RE: *Powell Replacement Elementary School, CPS, 7500 South Drive, Chicago, Illinois*
Dewatering Due Diligence Report by GeoSyntec Dated February 19, 2009

**POWELL REPLACEMENT
ELEMENTARY SCHOOL**
7511 S. SHORE DRIVE
CHICAGO, IL 60649

InterActive Design **DATE:** 05/01/09
308 W. Erie Street, Suite 506 **SHEET REFERENCE:** A9.1
Chicago, Illinois 60654 **SKETCH NUMBER:** ASK-040
P: 312-482-8866 F: 312-482-9904

SKETCH NUMBER: **SSK-001**

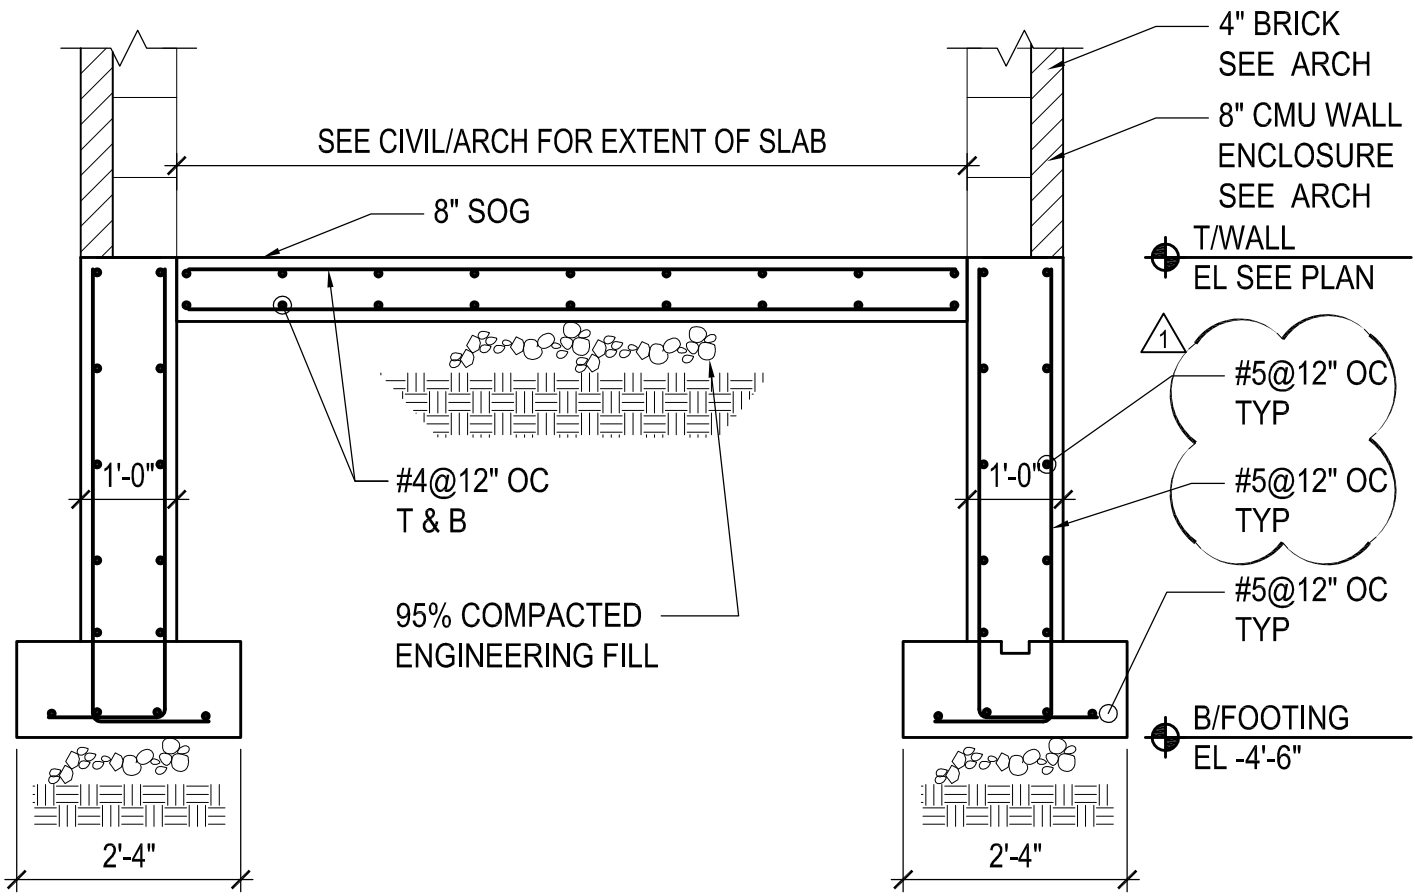
BEAM WEB PENETRATION SCHEDULE

MARK	TYPE	MAX SIZE (IN)				PLATES (t x WIDTH (IN))				WELD	REM
		W	H	DIA	e	TOP NS & FS	BOTTOM NS & FS	SIDE NS & FS	A		
A	U	12	4	-	d/2	-	-	-	-	-	-
B	U	12	6	-	d/2	-	-	-	-	-	-

1. TYPE REFERS TO TYPICAL BEAM WEB PENETRATION DETAILS.
2. THE MINIMUM CLEAR SPACE BETWEEN TWO ADJACENT PENETRATIONS SHALL BE GREATER OF THE LARGEST PENETRATION DIMENSION OR TWO TIMES THE BEAM DEPTH UON.
3. SEE STRUCTURAL DRAWINGS FOR QUANTITY AND LOCATIONS OF PENETRATIONS. ALL BEAM PENETRATIONS SHALL BE SHOWN ON THE SHOP DRAWINGS FOR REVIEW BY THE ARCHITECT/ENGINEER. NO PENETRATIONS SHALL BE MADE WITHOUT PRIOR REVIEW OF THE ARCHITECT/ENGINEER.
